TOWN OF WILLINGTON LIBRARY

CONCRETE & MASONRY REPAIRS

WILLINGTON PUBLIC LIBRARY 7 RUBY ROAD WILLINGTON, CONNECTICUT

ADDENDUM NO. 1

WILLINGTON PUBLIC LIBRARY CONCRETE & MASONRY REPAIRS SCALE: 1" = 30'

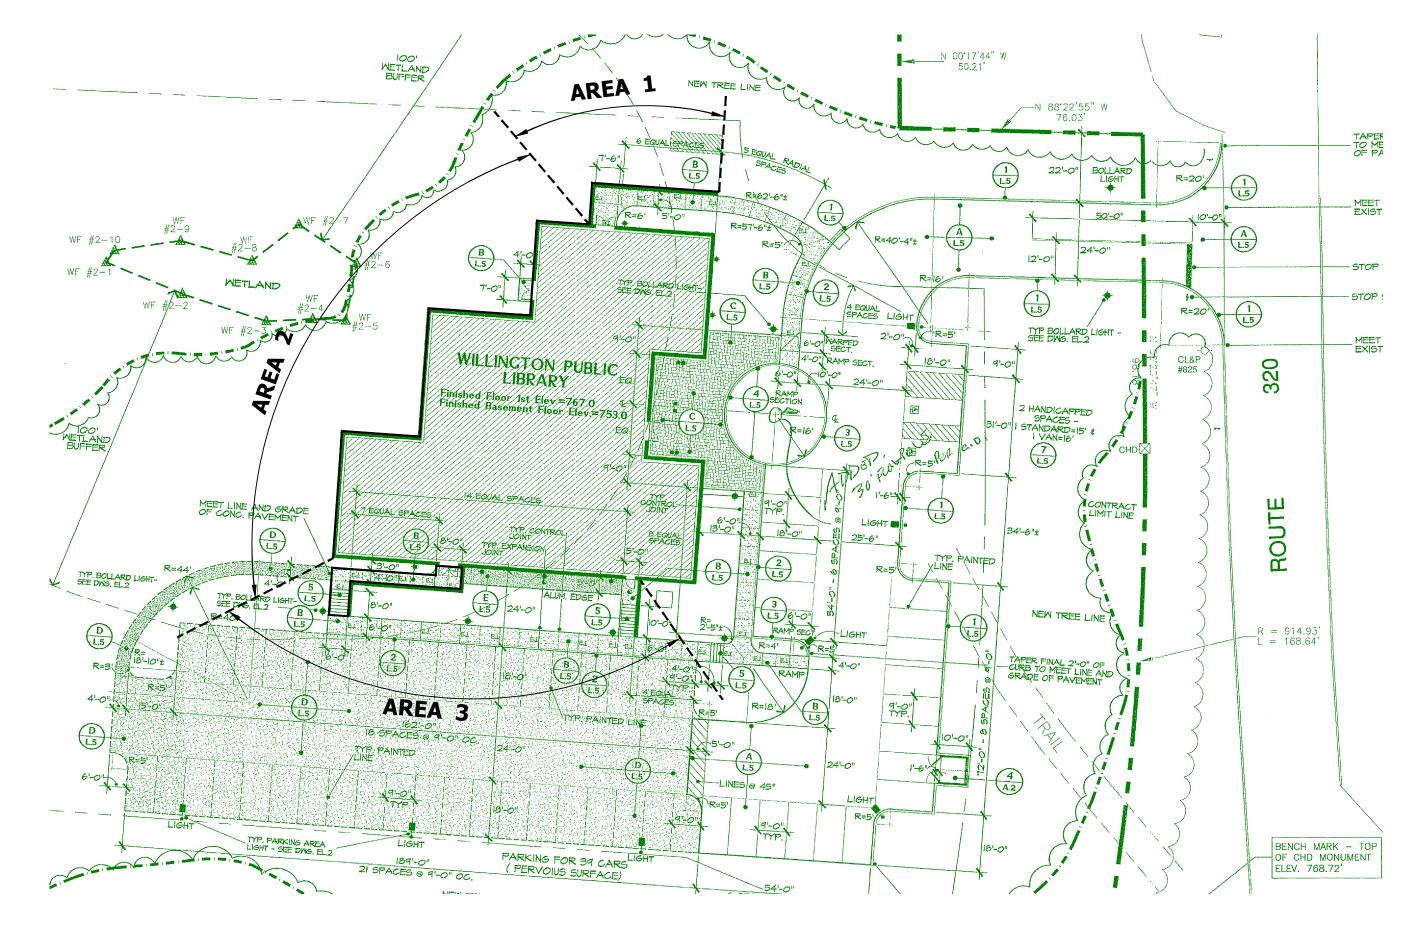
A revised sketch is attached to indicate the inclusion of an additional wall section for repairs to Area 3 at the easterly entrance on the south side of the building.

All bids shall take into account the inclusion and installation of drainage outlets along each of the retaining walls requiring repairs throughout Area 3. For short runs, this will include an outlet pipe with drainage fabric and a pervious gravel or crushed stone behind the wall and, for longer runs where sections are replaced, piping with drainage fabric and a pervious gravel or crushed stone along the back of the wall.
